STAFF REPORT

CITY OF COLUMBUS PLAN COMMISSION (February 12, 2025 Meeting)

Docket No. / Project Title: PUDF-2025-001 (Westwood Market)
Staff: Noah Pappas

Request Summary:

Date	Jan. 9, 2025
Job No.	24-110
Scale	1"=20'
Sheet No.	C300

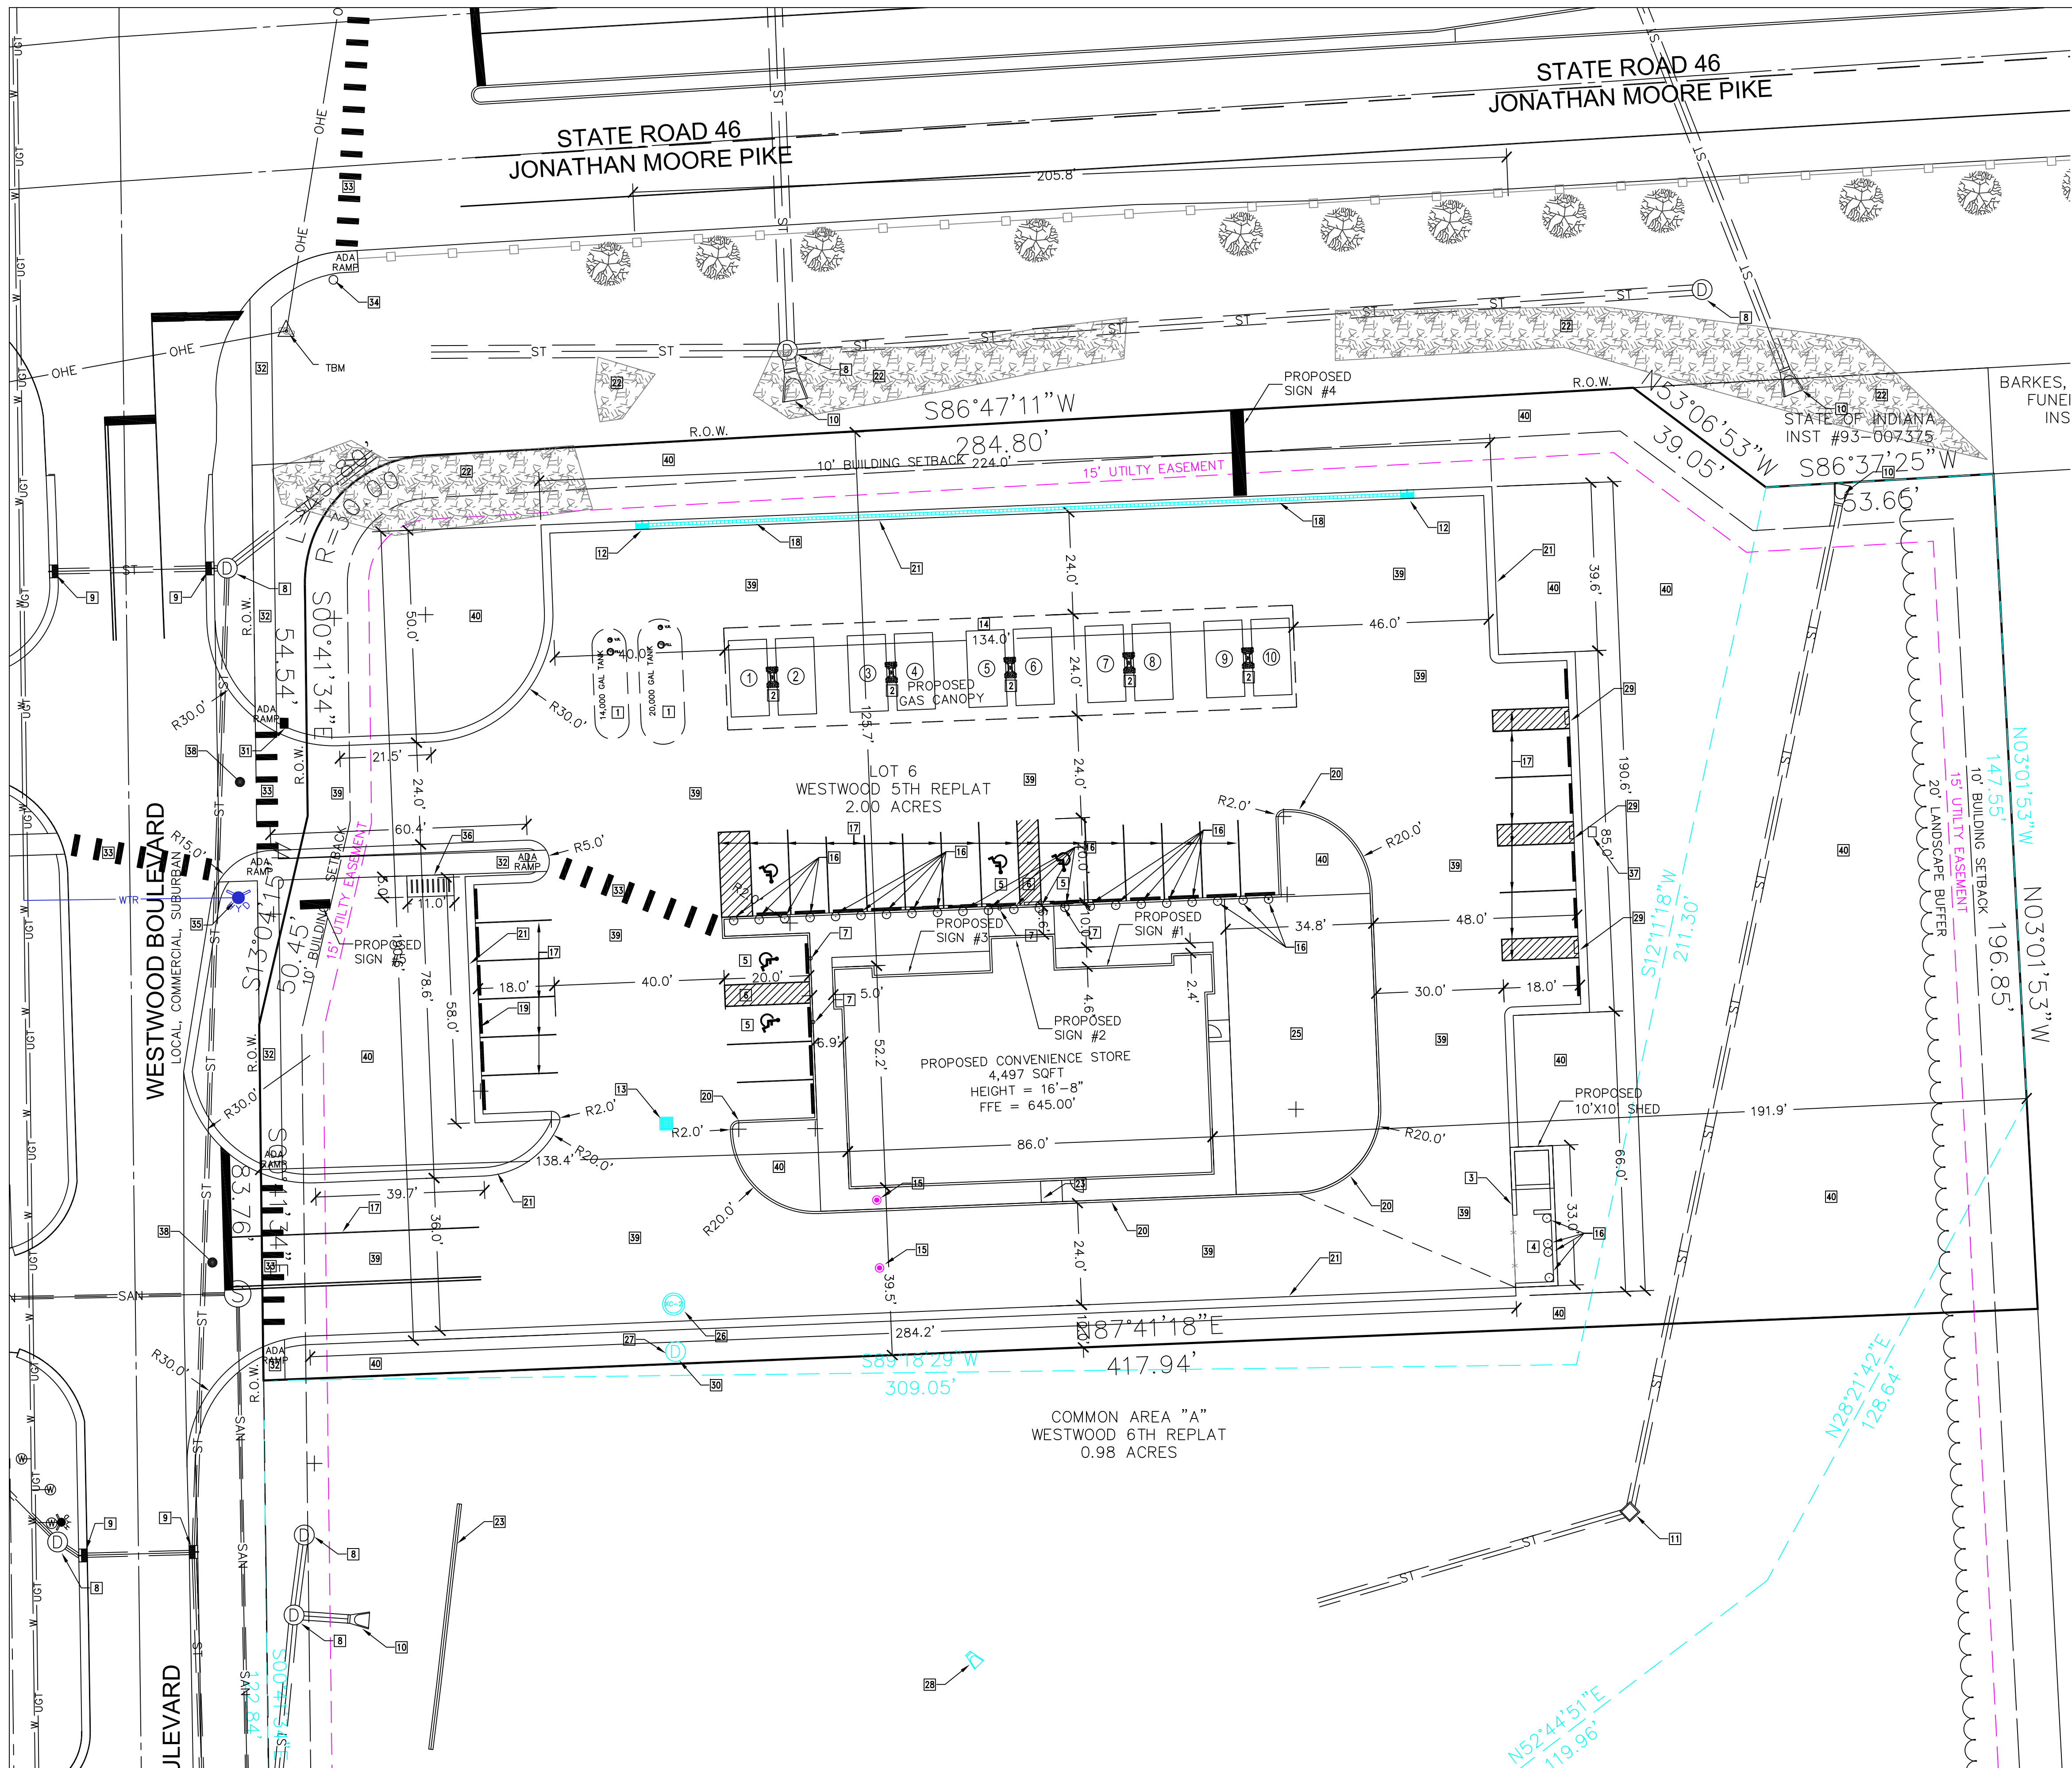
- f. Sheet C300, the Site Plan, shall include the following: (1) the State Road 46 Thoroughfare Plan street classification, (2) a label indicating the State Road 46 street trees as "to remain", (3) a label indicating all east property line vegetation as "to remain", (4) the correction of the shown 10-foot east property line building setback to the 70-foot setback required by the Preliminary PUD Plan, (5) the "no-access" easement along State Road 46 and its intersection with Westwood Boulevard established by the property's current subdivision plat, (6) intersection sight visibility triangles consistent with Zoning Ordinance Section 7.3(Part 1)(D)(5), (7) separation distances measured from the centerlines of all existing and proposed drives on Westwood Boulevard, (8) the width of all proposed sidewalks, (9) the relocation of the sidewalk - convenience store pedestrian connection and bicycle rack to the area of the south drive, and (10) the relocation of that portion of the Westwood Drive sidewalk that is outside the public right-of-way or the provision of this sidewalk with additional dedicated right-of-way or an appropriate easement. Also, the proposed crosswalk across Westwood Boulevard shall be omitted.

Interdepartmental Review:	
City Engineering:	<p>Comments on the revised plans:</p> <ul style="list-style-type: none"> - Engineering does not support the addition of the north driveway. This driveway is encroaching into the functional area of the traffic signal at SR46 and Westwood Blvd. This drive will have a negative impact on the function and safety of the signal. - Should the bike rack be located closer to the building? - The internal sidewalk from the Westwood Drive public sidewalk to the building should be relocated. In its current position a pedestrian has a long crosswalk with many conflict points. Consider placing the sidewalk along the south side of the south entrance. This will allow a pedestrian to make one crossing perpendicular to vehicular traffic. - Remove the mid-block crossing on Westwood Blvd. - A pedestrian easement or additional right of way will need to be dedicated any location the sidewalk is outside of the existing Right of Way. - The existing stormwater forebay in the shared detention area needs cleaned. - A stormwater permit will be required for this site. - An Improvement in the Right of Way permit (https://www.columbus.in.gov/engineering/improvement-in-the-right-of-way/) will be required for any sidewalk, curb, driveway entrance constructed in the Right of Way. - A Street Cut Permit (https://www.columbus.in.gov/engineering/forms/permit-to-excavate/) will be required for any excavations in the public Right of Way - A Special Use of Right of Way (https://www.columbus.in.gov/engineering/forms/request-for-special-use-of-right-of-way/) will be required for any lane restriction or street closure. - An INDOT permit will be required, please coordinate with INDOT on any permit requirements for work completed in State Right of Way.

City Utilities:	No response.
Fire Department:	I would like to ask the applicant to install a fire hydrant on the east side of Westwood somewhere in the proximity of the entrance to the site.

INDOT:	INDOT does not have any objections to the site plan and driveway access proposed. INDOT would require sidewalk from the driveway to SR 46 and then APS compliant pedestrian crossings on the east approach through the traffic signal. This site has been discussed before and basically the sidewalk on the NE quadrant of SR 46 and CR 325 W would need to be connected to this site with an accessible crossing over SR 46.
---------------	--

SHEET TITLE:		3D VIEWS	
WESTWOOD MARKET			
4325 W. JONATHAN MOORE PIKE, COLUMBUS, IN. 47201			
COLUMBUS	COLUMBUS TOWNSHIP	BARTHOLOMEW CO.	INDIANA

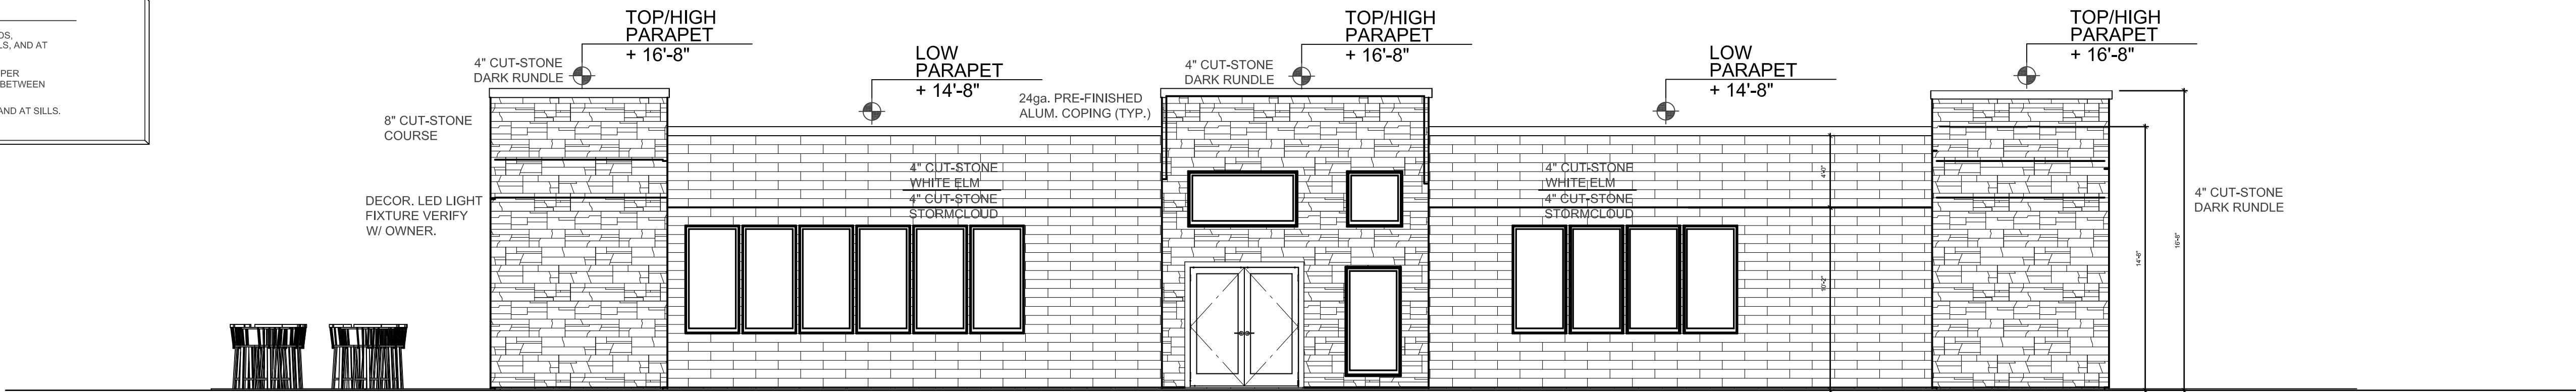
2. The convenience store renderings shall be revised to be consistent with the site plan, specifically with regard to landscaping at the front of the building and the outdoor seating area.

SHEET TITLE: ELEVATIONS	WESTWOOD MARKET	INDIANA
	4325 W. JONATHAN MOORE PIKE, COLUMBUS, IN 47201	
	COLUMBUS TOWNSHIP	
	COLUMBUS

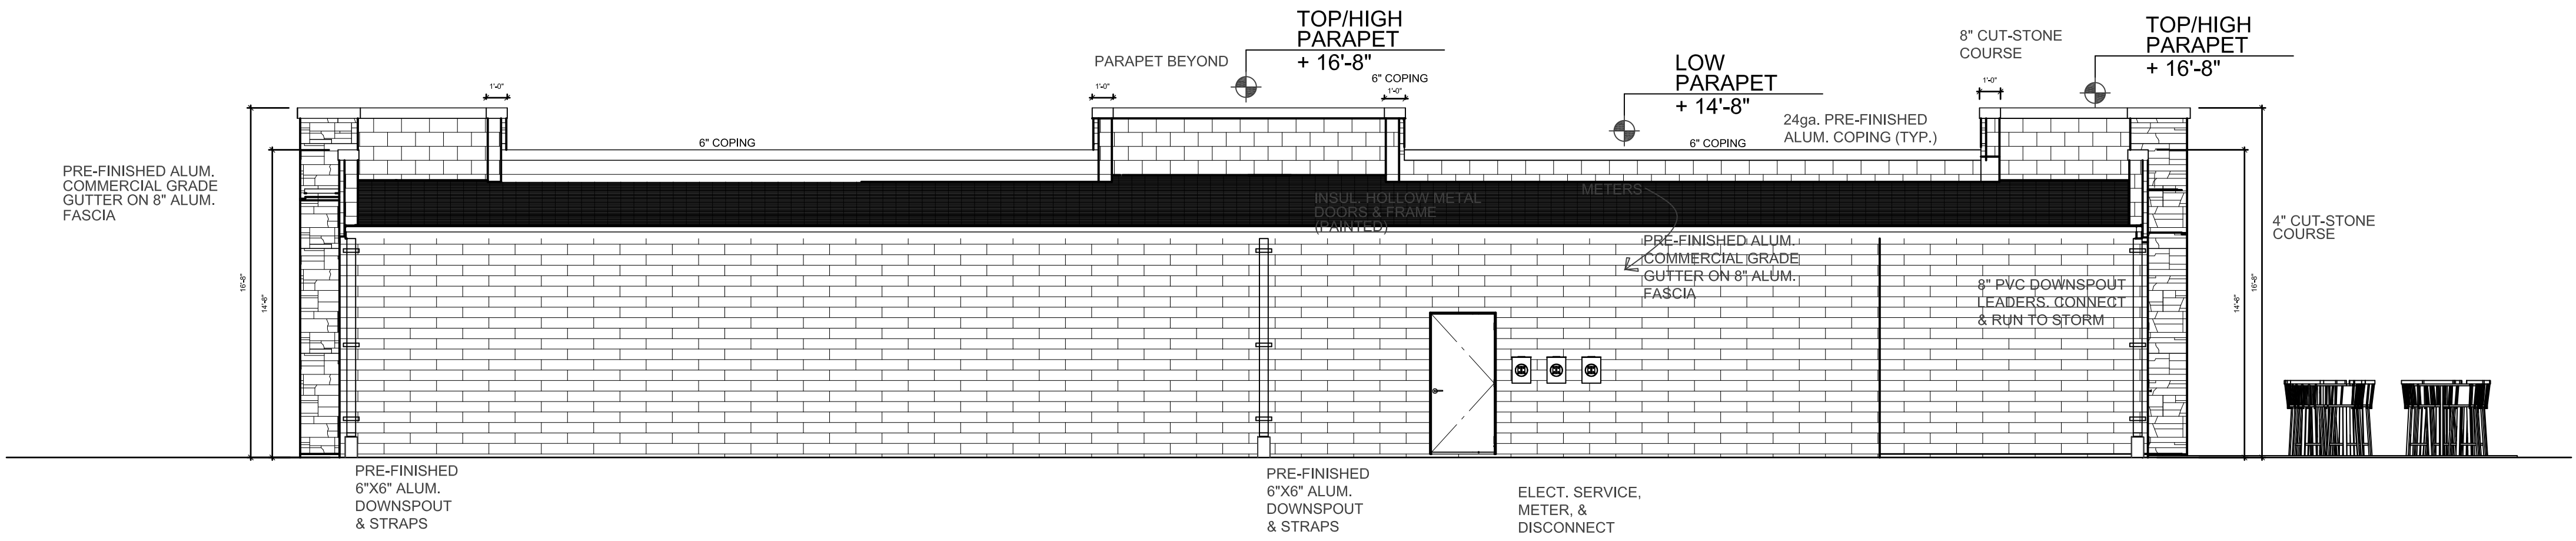
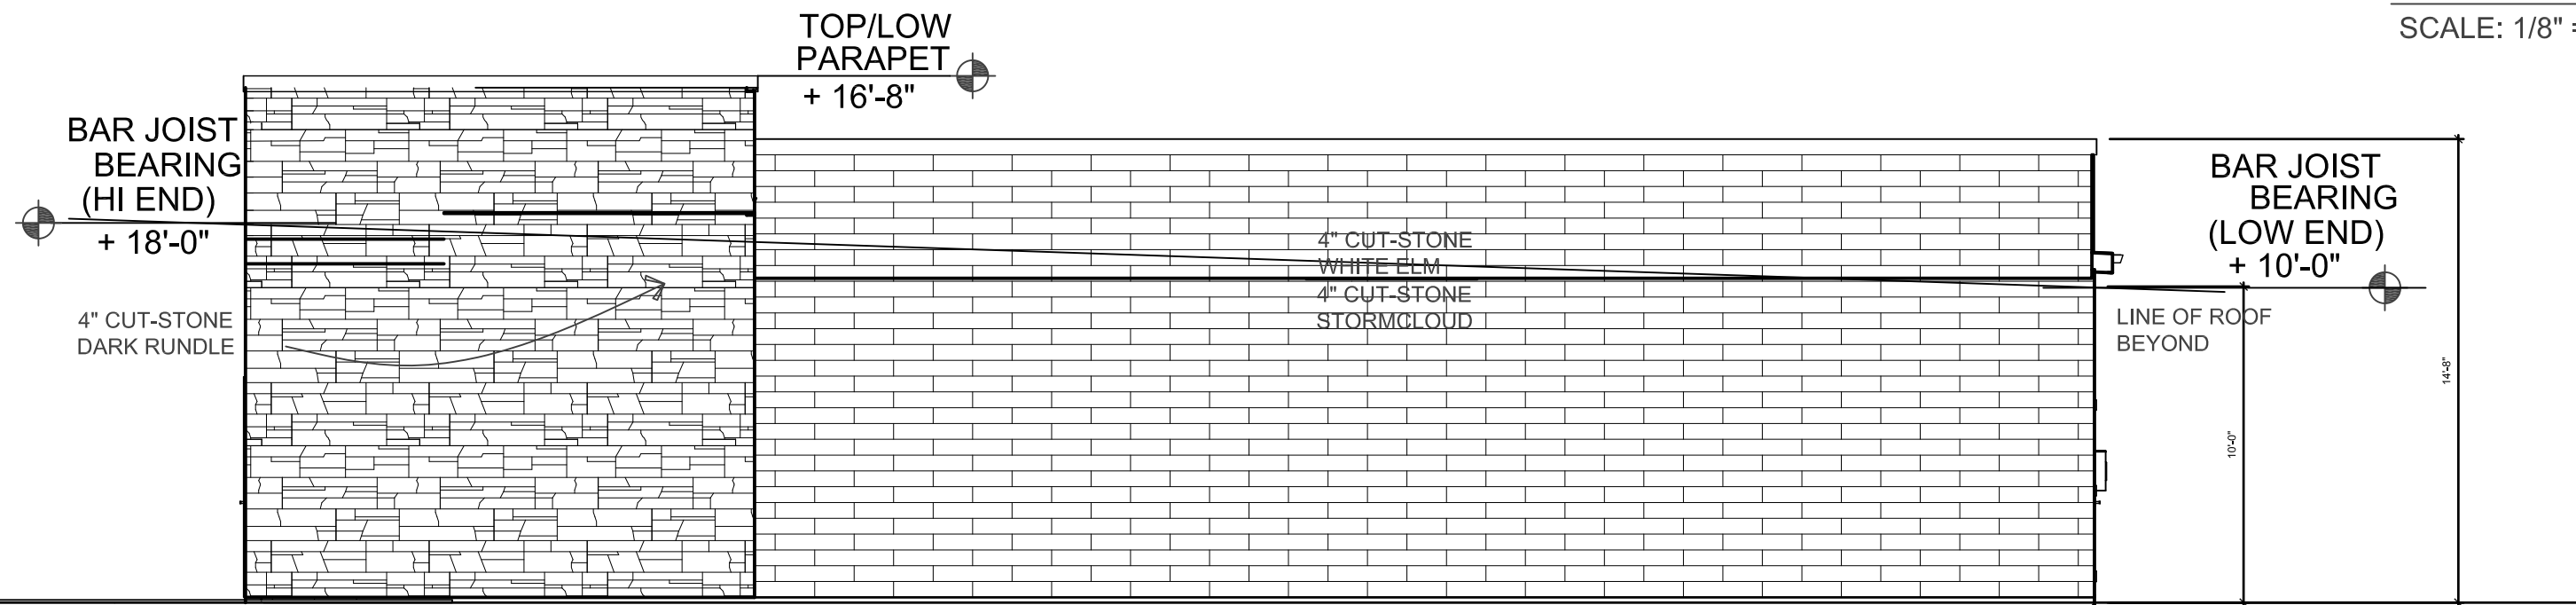
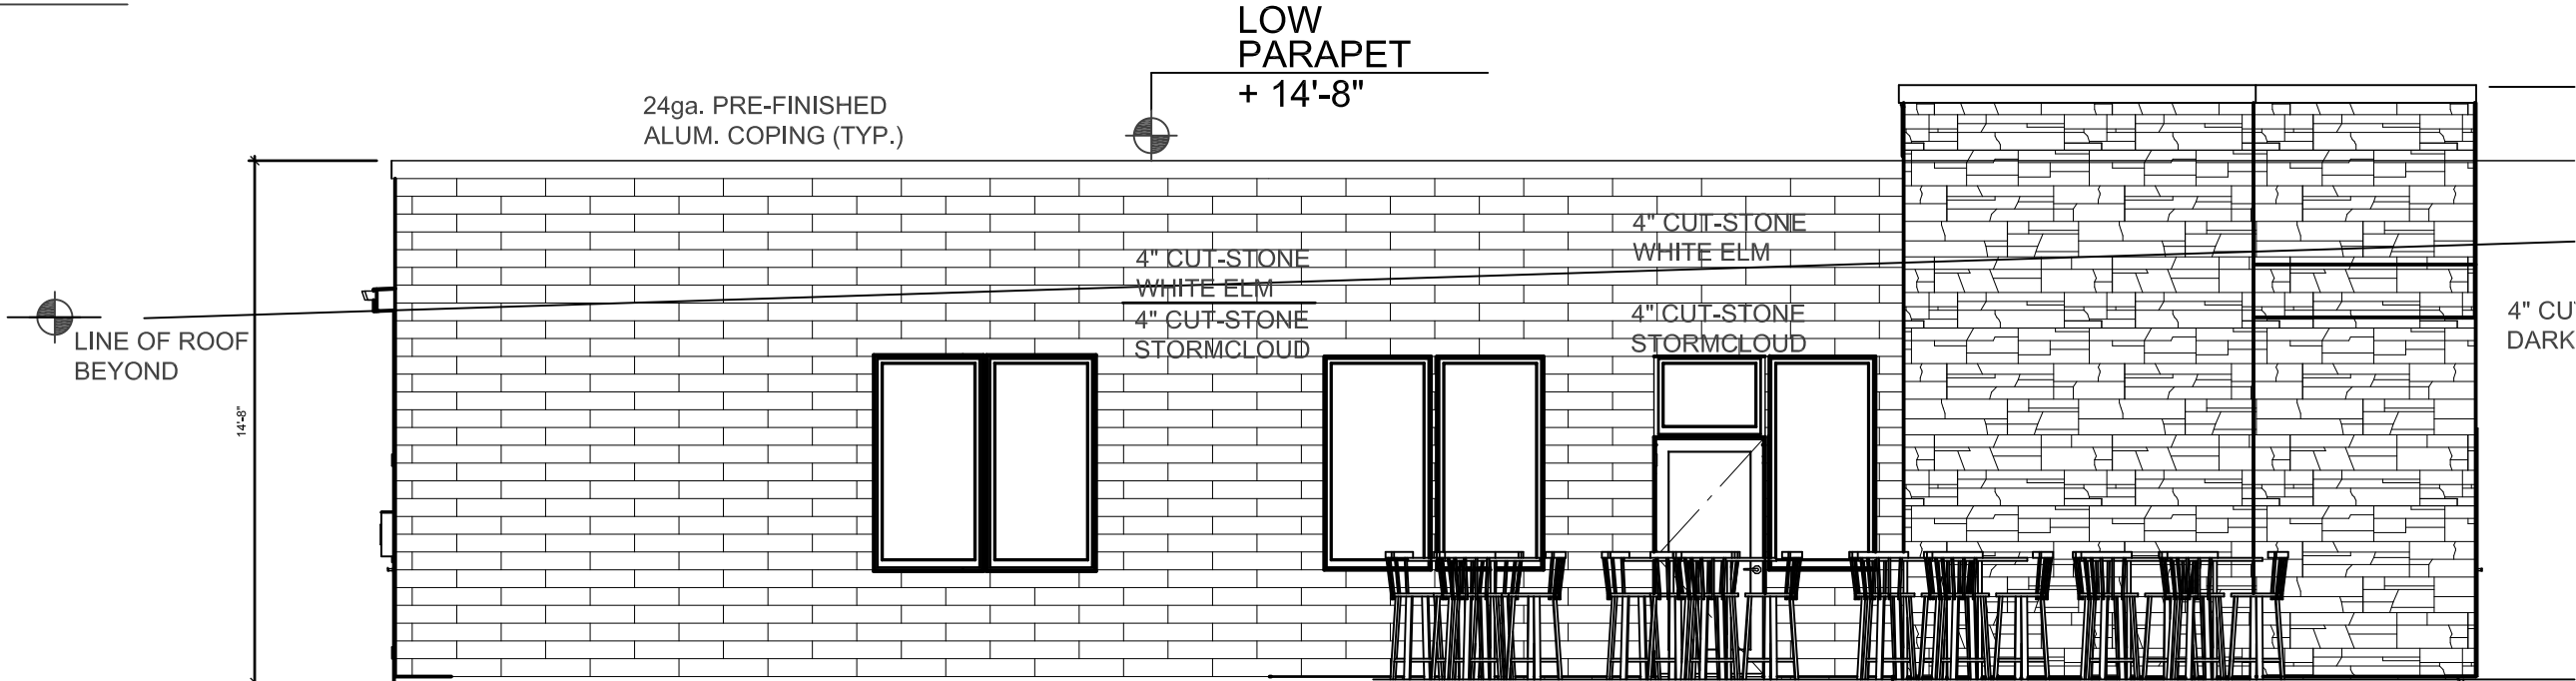
3. The convenience store elevation drawings shall be revised to be consistent with the site plan, specifically with regard to landscaping at the front of the building and the outdoor seating area. Also, the building's south façade materials shall be labeled and all roof-top mechanical equipment shall be shown and adequately screened from public view.

2. The proposed convenience store building will be constructed primarily of a mix of stone and brick, however the materials for the back (south facing) side of the building are not conclusively labeled. The applicant has submitted a rendering showing the gas canopy columns as having brick generally consistent with the building design with the canopy to be branded consistent with the gas vendor. The proposed site plan also includes a trash enclosure / shed structure. While it appears this structure is intended to be consistent with the design of the convenience store, the building materials
